**11<sup>th</sup> CSPCWG/1<sup>st</sup> NCWG Meeting  
Rostock, Germany, 27-30 April 2015**

**Paper for Consideration by CSPCWG/NCWG**

**Covered Berths – Further Considerations**

<b>Submitted by:</b>	Australia
<b>Executive Summary:</b>	Discussion on the depiction of covered berths on paper charts by CSPCWG Letter has identified additional issues that require further consideration of the CSPCWG/NCWG.
<b>Related Documents:</b>	<ol style="list-style-type: none"> <li>1. CSPCWG10-08.10A_Covered_berths;</li> <li>2. CSPCWG Ltr 10-2014 CSPCWG10 Actions 15 and 18-21;</li> <li>3. CSPCWG Ltr 14-2014 Actions 15 &amp; 18-21 Follow-up to CSPCWG Letter 10;</li> <li>4. S-4 – B-321.9;</li> <li>5. INT1 – D5 (BSH (7<sup>th</sup> Edition 2011).</li> </ol>
<b>Related Projects:</b>	S-4 Maintenance; INT1 Maintenance.

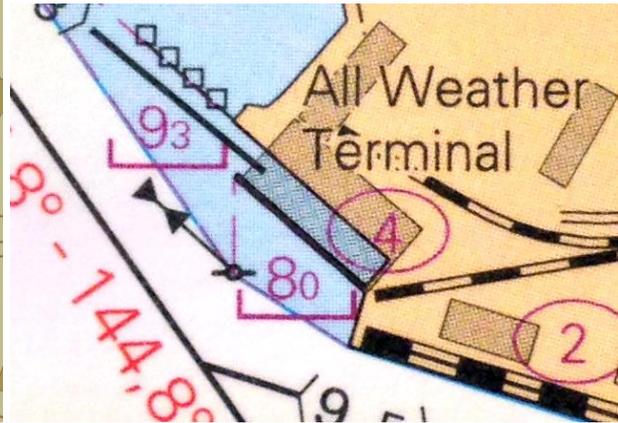
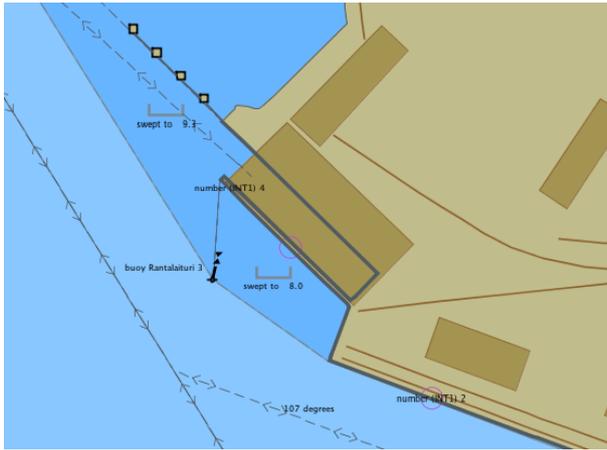
21: We also think that this needs more working on. The proposed symbol does seem "incomplete" without a line on the edge. Many of these structures, like the one shown in CSPCWG10-08.10A, do have solid walls making them physical obstructions. A tint only symbol does not feel like an obstruction.

21: At the moment Italian HO has no information about "Covered wharf". Don't you think that the proposed representation may be confused with a mistake of the land tint?

21: B-321.9 – We agree that symbol is needed. From our point, the symbol looks a bit unfinished though.

As NOAA suggests, it could be solid line or may be dashed line around the tint (N1.2), so indicating “water area” it covers and it is also possible to add also note to this “area” if needed (limit could also be useful to encode it to ENC as area with info). Also unclear a bit is profile picture against the added chartlet. Profile has posts in the water holding the roof, so there should be maybe minor piles in the water also under the building tint. Maybe also there should be then shown possible entry and exit paths (arrows of kind), if piles are not just in the corners, but more along the outer edge of a tint?

21: Section B-321.9: I don't feel strongly about this, but the image proposed for B-321.9 looks like what could be mistaken for a tint error. I realize that there is a vertical clearance shown, but a black line around the perimeter would give a quicker impression that this is a structure. Hydrography would still show through. The profile is a nice touch if there is room on the chart.

**Chairman:** Agree further discussion about an 'edge', roof supports, detached wharves and how to depict on charts which do not use urban tint is necessary. AU will prepare a paper for CSPCWG11.

**Chairman:** See response to Finland. It occurs to me that the term ‘pictorial sketch or photograph’ may be more consistent with S-4 and INT1.
